**DOCUMENT TYPE:** POD  
**DOCUMENT ID #:** 21-100684  
**REVISION:** B-000  
**DOCUMENT TITLE:** PACKAGE OUTLINE 132 BUMPS THIN WLP PKG.  
**EFFECTIVE DATE:** 09/24/2024  
**EXPIRATION DATE:**  
**CHANGE NUMBER:** 1217032  
**ORIGINATOR:** Shaira Isabel Torre

TITLE		
PACKAGE OUTLINE 132 BUMPS THIN WLP PKG. 0.35 mm PITCH, N1324B4Z+1		
APPROVAL	DOCUMENT CONTROL NO.	REV.
	21-100684	B 1/1

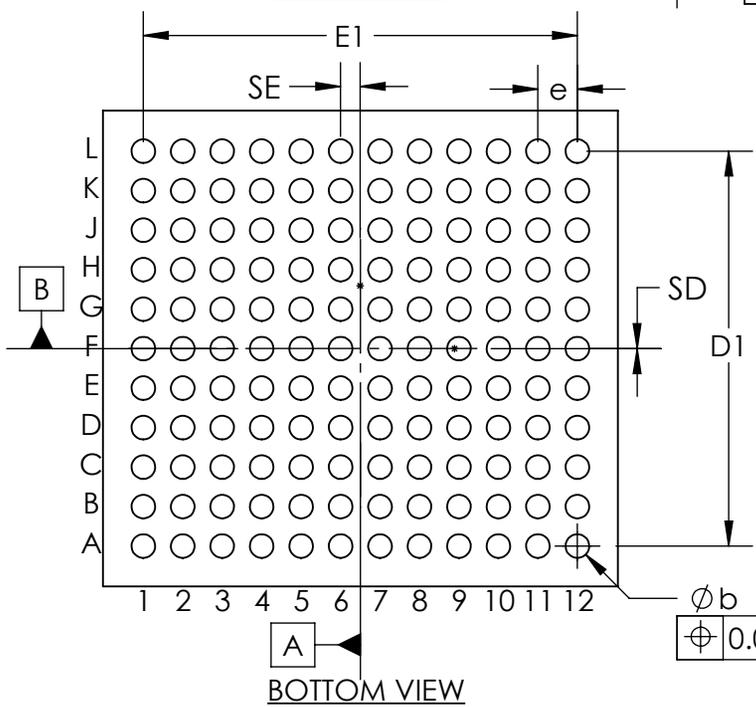
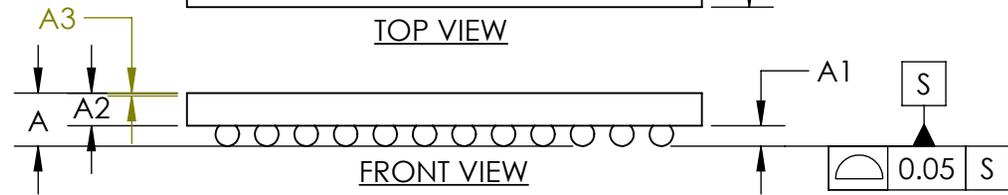
Change A value from 0.50 to 0.45, change A2 value from 0.29 to 0.24 and removed A3 value.

COMMON DIMENSIONS	
A	0.45 MAX
A1	0.18 ±0.03
A2	0.24 REF
A3	0.00 BASIC
b	∅0.21 ±0.03
D	4.218 ±0.025
E	4.568 ±0.025
D1	3.50 BASIC
E1	3.85 BASIC
e	0.35 BASIC
SD	0.00 BASIC
SE	0.175 BASIC
DEPOPULATED BUMPS: NONE
